Access Compliance Report

Public Rights-of-Way

Intersection ID: 20994	Main Street: BLUESHOT_CT	Cross Street: BRICKER_DR	Location: W
ADA ID: 51C9322032DB	Ramp Type: PerpDiag	Initial Pass/Fail: Fail	Overall Compliance: No
		Severity Score: 12.5

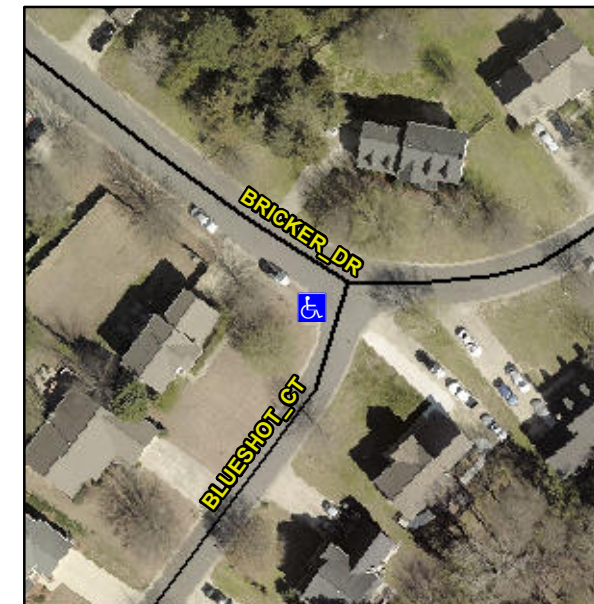
Not Found, R304.5.3

Compliance	Description	Data	Compliance	Description	Data
N/A	Ramp Length (in)	48.0	Yes	Ramp Slope (%)	5.7
Yes	Ramp Width (in)	48.0	No	Ramp XSlope (%)	5.9
N/A	Flare Type LT	N/A	N/A	Flare Type RT	N/A
N/A	Flare Slope LT (%)	N/A	N/A	Flare Slope RT (%)	N/A
N/A	Flare Traversable LT?	N/A	N/A	Flare Traversable RT?	N/A
N/A	Landing Length (in)	N/A	N/A	DWS Provided?	N/A
N/A	Landing Width (in)	N/A	N/A	DWS Contrast?	N/A
N/A	Landing Slope (%)	N/A	N/A	DWS Length (in)	N/A
N/A	Landing X Slope (%)	N/A	N/A	DWS Full Width?	N/A
N/A	Landing Curb? (Y/N)	N/A	N/A	DWS Offset (in)	N/A
N/A	Shared Landing?	N/A			
N/A	Gutter Ponding?	N/A	N/A	Gutter Slope (%)	N/A
N/A	Gutter Lip Ht (in)	N/A	N/A	Gutter X Slope (%)	N/A
N/A	Painted X Walk1?	No	N/A	Painted X Walk2?	No
	X Walk 1 Direction	To SE		X Walk 2 Direction	To NE
N/A	X Walk 1 Width (in)	N/A	N/A	X Walk 2 Width (in)	N/A
	X Walk 1 Slope (%)	0.5		X Walk 2 Slope (%)	5.0
	X Walk 1 X Slope (%)	4.1		X Walk 2 X Slope (%)	0.1

Remove & Replace Curb Ramp With Two New Directional Ramps or Equivalent.
